TOWNSHIP 21 SOUTH, RANGE 4 WEST, OF THE WILLAMETTE MERIDIAN, OREGON

AMENDED PLAT

UNITED STATES DEPARTMENT OF THE INTERIOR
BUREAU OF LAND MANAGEMENT

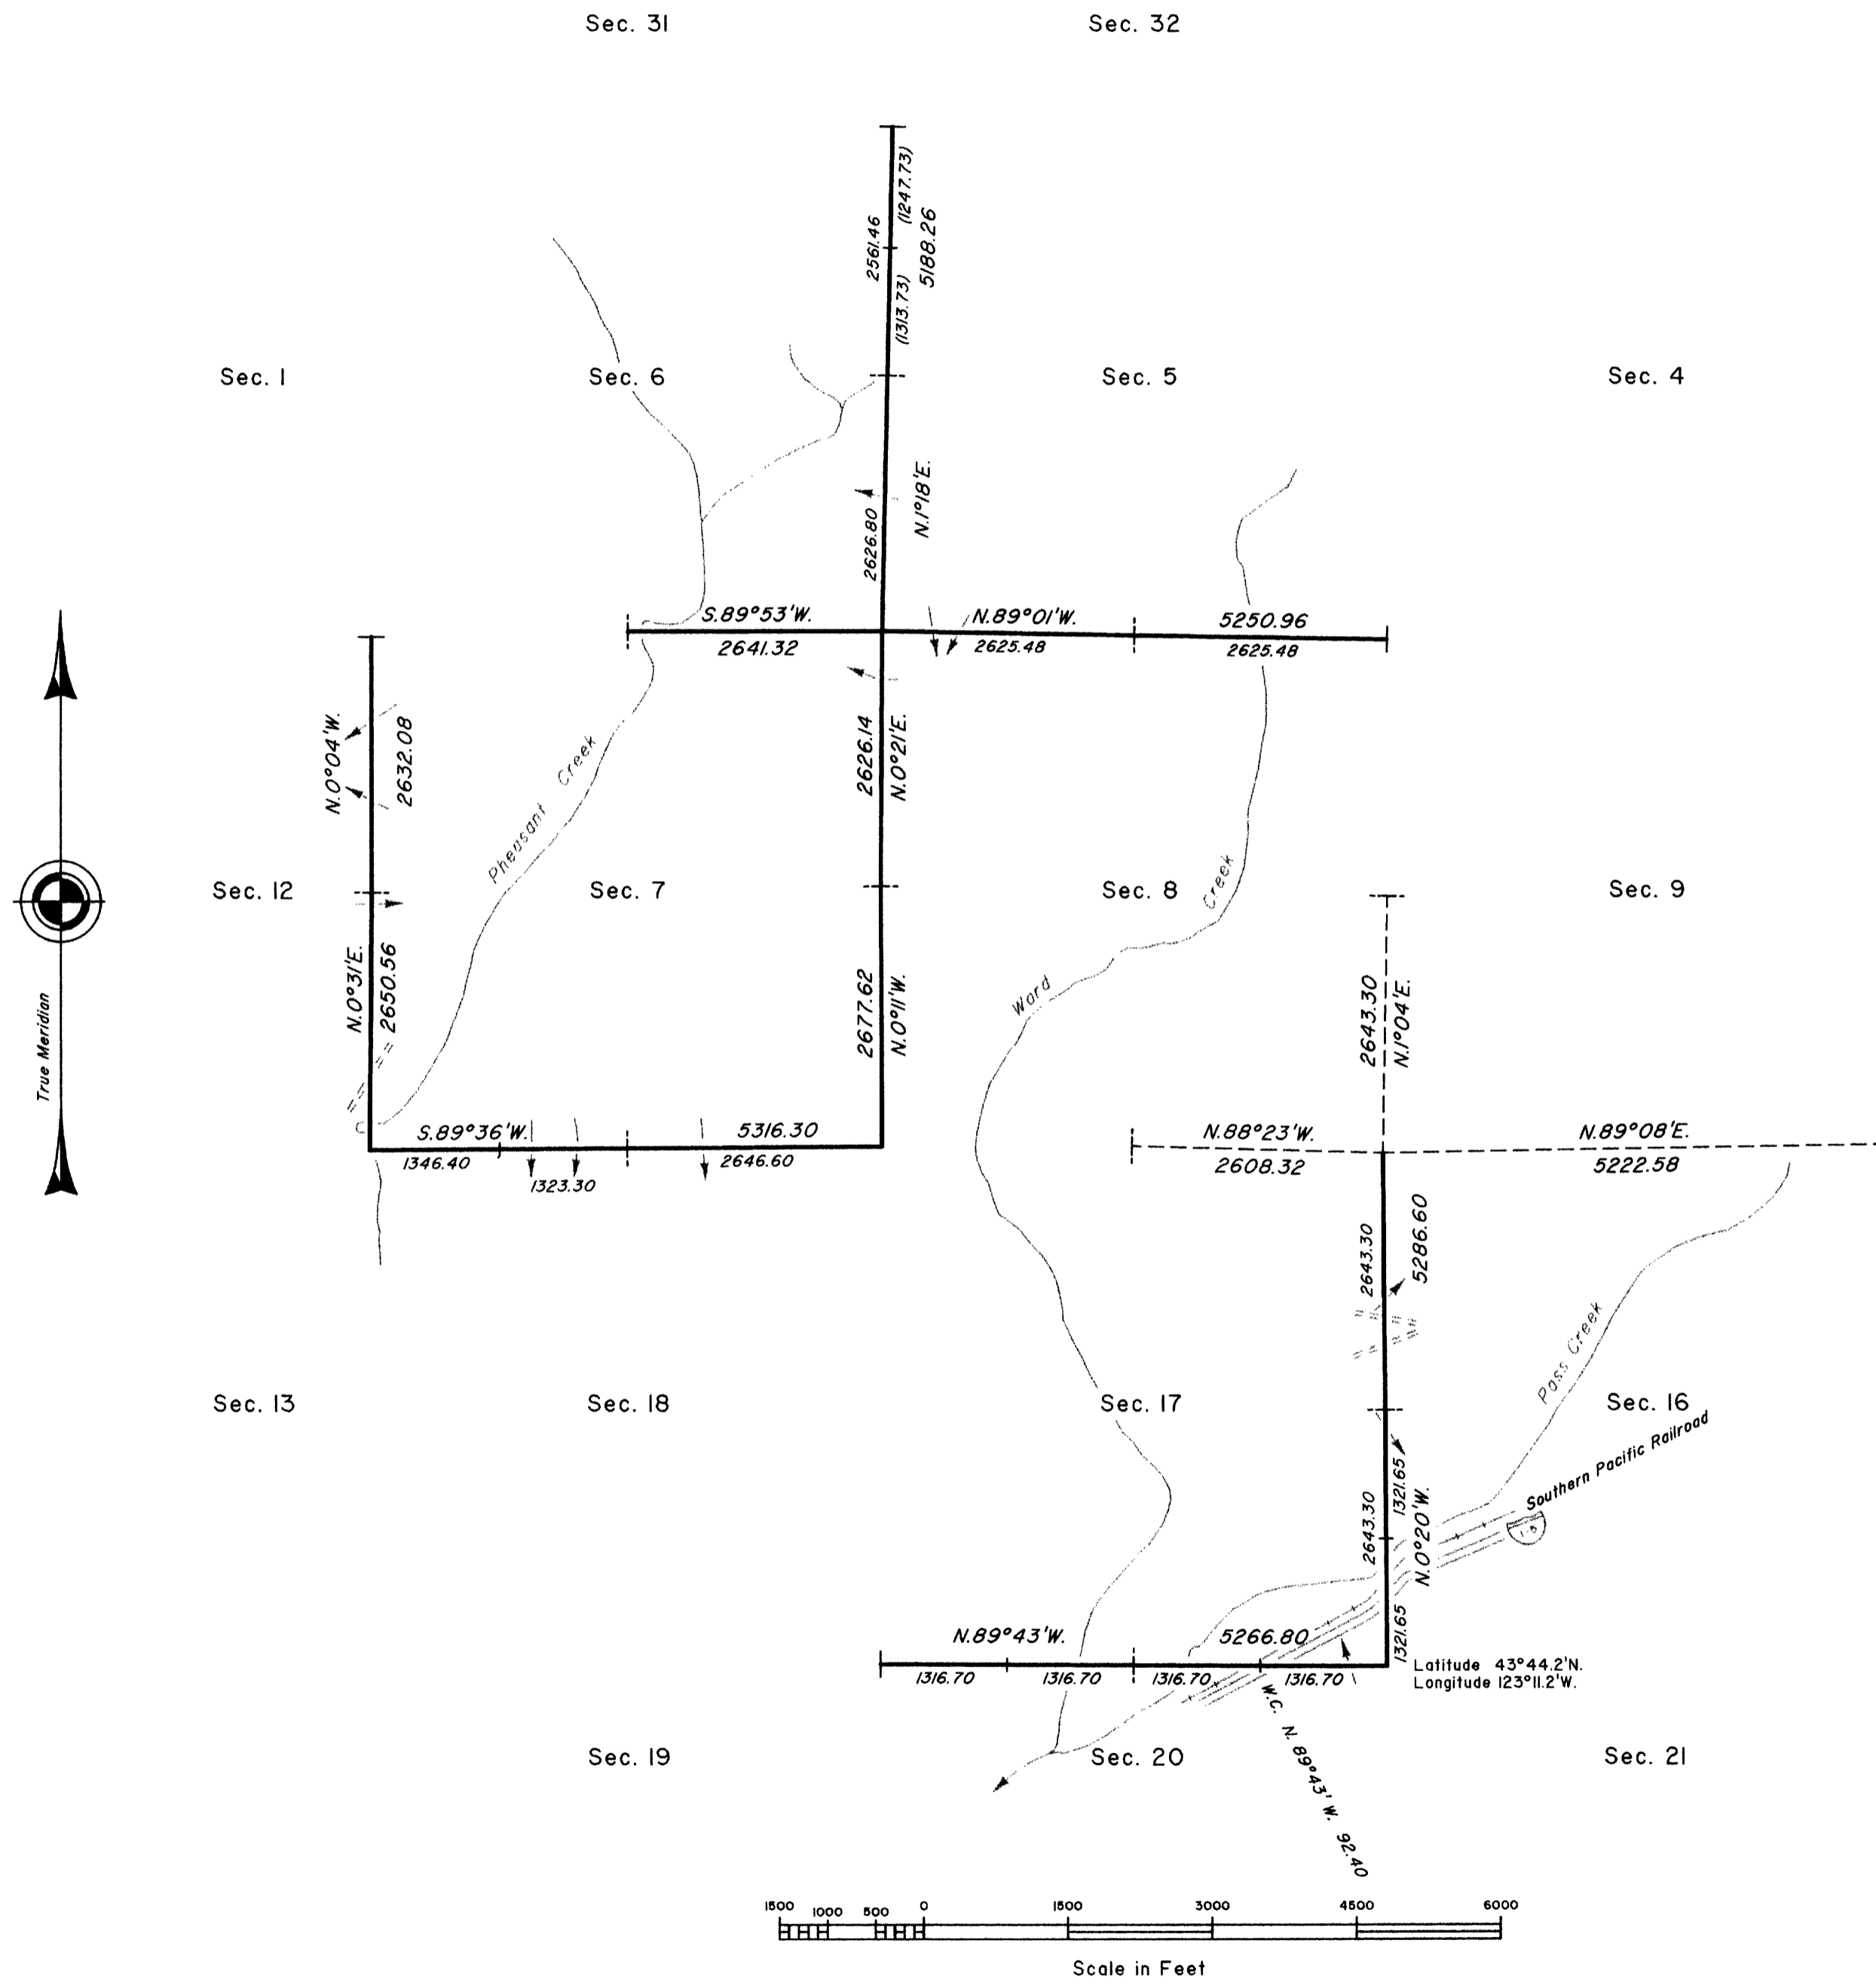
This plat corrects the bearing, erroneously shown as N. 0° 31' W., on the south 1/2 of the section line between secs. 7 and 12, on the official plat accepted March 30, 1977. The bearing on the south 1/2 of the section line between secs. 7 and 12 is now shown as N. 0° 31' E. This amended plat is authorized by memorandum from the Chief Cadastral Surveyor of Oregon, dated March 15, 2013, file 9632 (OR957).
